Proposed development of Wimbledon Park Lake and surrounds. Planning submission on AELTC proposals. June 2022.

Dr D.G. Dawson

Summary

Figure 1. Circular walkway options. © Capability Brown Society 2022.

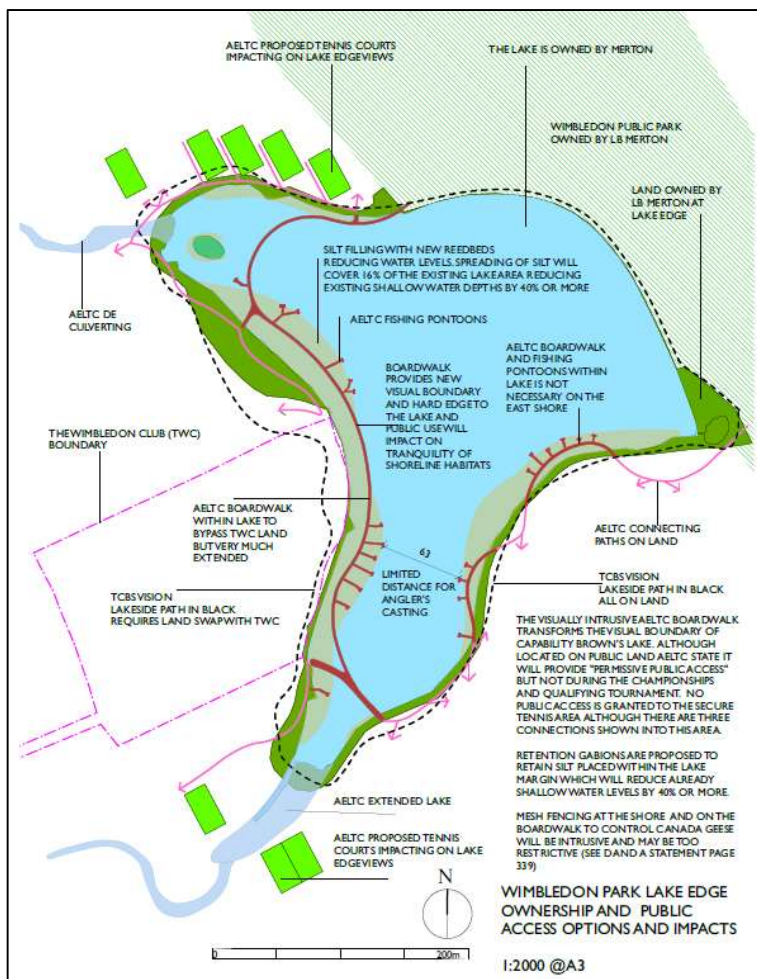
However, it is claimed that views are improved by taking the proposed circular walkway over the western and southern arms of the lake, rather than around its perimeter³⁰. Clearly the converse is the case. Taking the walkway over the lake harms heritage design by preventing views of open water beyond, so effectively truncating the two arms of the lake and ensuring that they no longer give the impression of a sinuous water body continuing off into the distance³¹. The EIA states that: "...consideration should be given to whether the adverse effect of the boardwalk on the heritage significance of Wimbledon Park RPG could be reduced by design (e.g. by avoiding crossing the lake tips and/ or reducing the number of jetties)."³²

There is no shortage of land around the perimeter of the lake to route a terrestrial walkway and avoid this serious intrusion into historic views³³.

Figure 2. An alternative vision of a circular, lakeside walkway wholly on lakeside land. © Capability Brown Society, 2022²⁹.

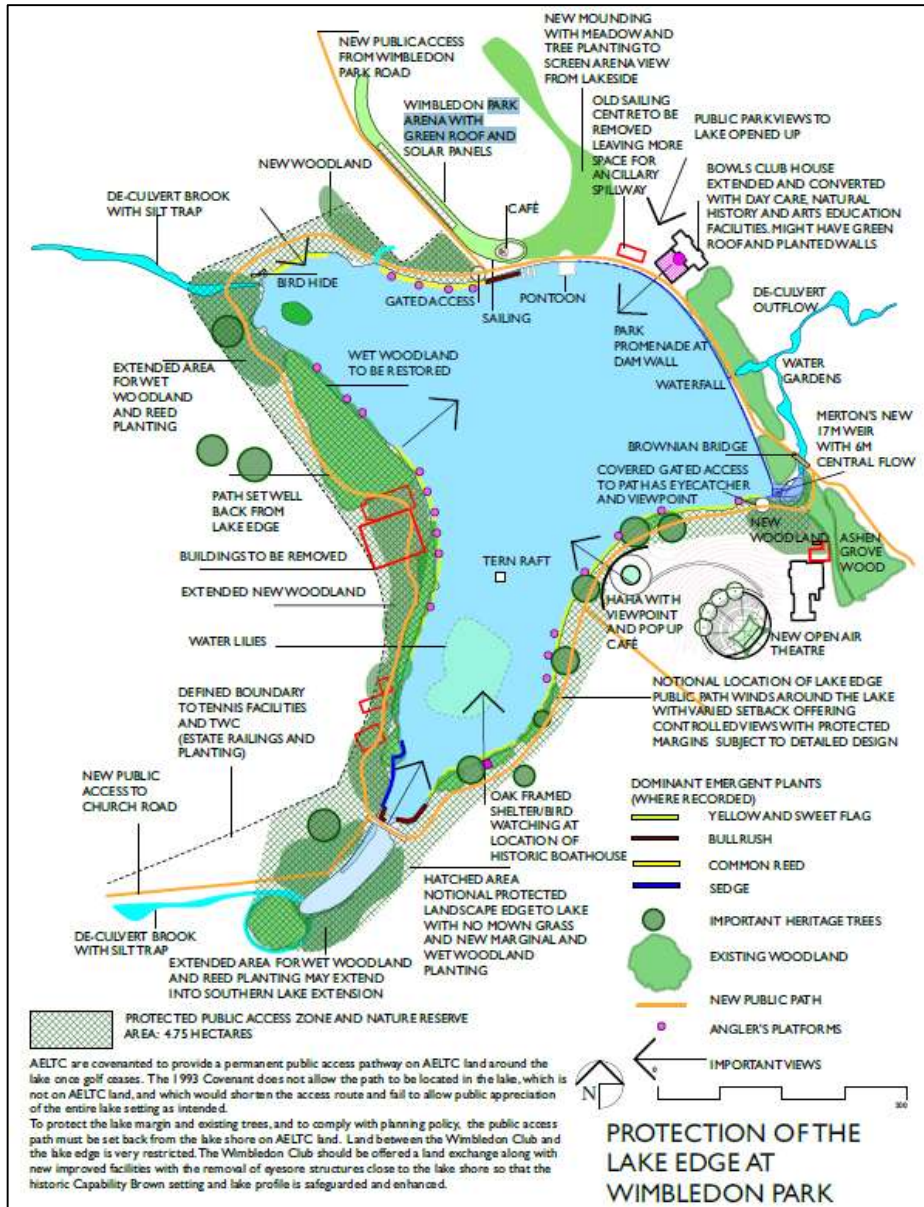
AELTC do not consider any explicit alternative to their damaging circular walkway design. They do not mention the existing positive obligation, enforceable in public law, to provide a lakeside walkway once golf should cease. Using this obligation as a starting point, and negotiating a sensible land swap, allows alternative circular walkway designs. Use of the existing access route on the western edge of the lake is possible (see above), and another alternative is reproduced as Figure 2 above. Although this independent vision gets no mention in the AELTC application, it surely shows that there are less damaging alternatives than the proposed walkway constructed largely within the lake and which would better meet with AELTC's own brief for a circular walkway³⁴. It is informative that the *Landscape addendum* puts the walkway over lake water because of limited land availability³⁵. I suggest, rather, that the ambition of AELTC for a huge number of new grass courts is what limits the availability of land for honouring a community obligation and providing a great community asset.
